Project	<b>IEEE 802.16 Broadband Wireless Access Working Group</b> < <a href="http://ieee802.org/16">http://ieee802.org/16</a> >	
Title	<b>Interference Detection and Measurement in OFDMA Relay Networks</b>	
Date Submitted	<b>2007-01-08</b>	
Source(s)	Wei-Peng Chen <a href="mailto:wei-peng.chen@us.fujitsu.com">_</a> Chenxi Zhu Fujitsu Laboratories of America	<a href="mailto:wei-peng.chen@us.fujitsu.com">wei-peng.chen@us.fujitsu.com</a> <a href="mailto:chenxi.zhu@us.fujitsu.com">chenxi.zhu@us.fujitsu.com</a> Voice: +1 408-530-4622
	Dorin Viorel <a href="mailto:dviorel@fmci.fujitsu.com">_</a>  Fujitsu Microelectronics Canada Inc.	<a href="mailto:dviorel@fmci.fujitsu.com">dviorel@fmci.fujitsu.com</a>  Voice: +1 403-207-6311
	<a href="#">Yong Sun, Dharma Basgeet, Zhong Fan, Paul Strauch</a>  <a href="#">Toshiba Research Europe</a> <a href="#">Peter Wang</a>  <a href="#">Nokia</a>	<a href="mailto:Sun@toshiba-trel.com">Sun@toshiba-trel.com</a>

# Interference Detection and Measurement in OFDMA Relay Networks

Figure 1 Example of a (1,1,3) network topology.

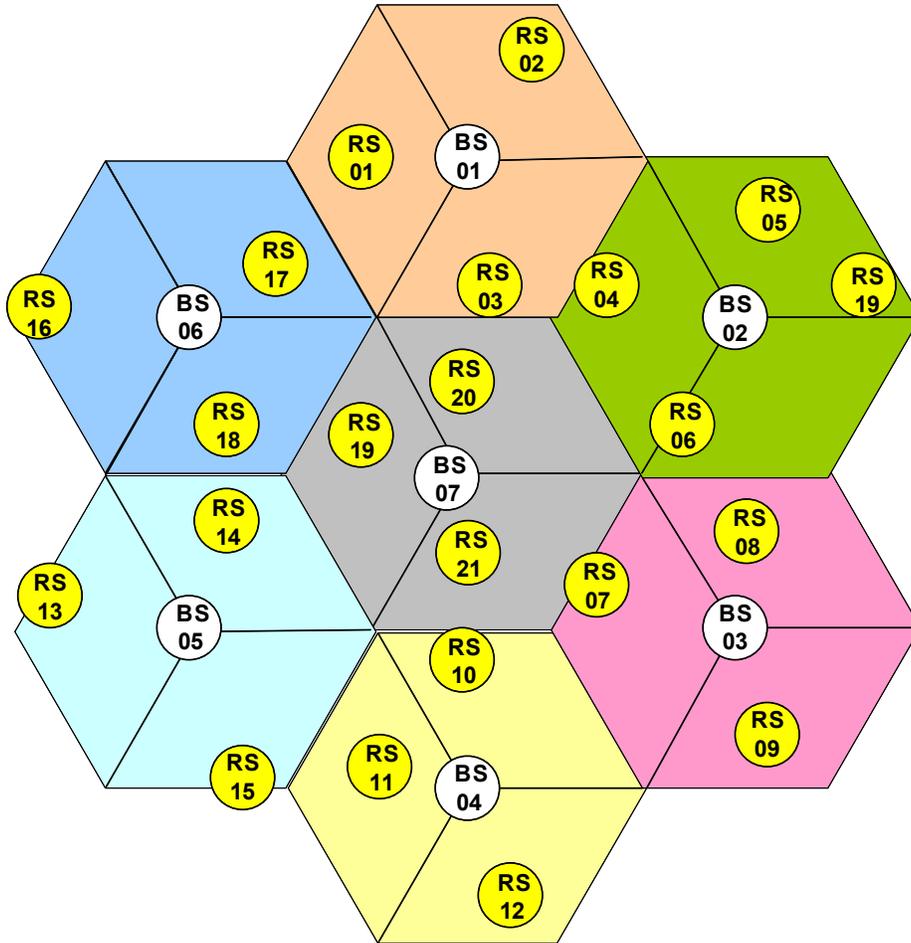
~~Based on the example presented in Figure 1 and considering an interference detection algorithm based on the access preamble, as generated by any the 802.16e Base Stations, any RS positioned in inside the cluster of cells subject to the interference measurement and management, will receive and it could detect the related preamble symbol sequence. Further processing will be applied (e.g. RSSI or SINR), subject to the implementation. These processing results shall be reported back to the MR-BS and further to the network management entity, in order to allow further interference management decisions (implementation specific).~~

Based on the example presented in Figure 1 and considering an interference detection algorithm based on interference pattern built upon the UL sounding structure (implementation specific) , as generated simultaneously by one or more first hop Relay Stations, any BS positioned in inside the cluster of cells subject to the interference measurement and management, will receive and attempt to detect the preamble symbol. Further processing will be applied (e.g. RSSI or SINR), which is implementation specific. These processing results shall be measured by the MR-BS and ~~reported back to the MR-BS and~~ further to the network management entity, in order to allow further interference management decisions (implementation specific).
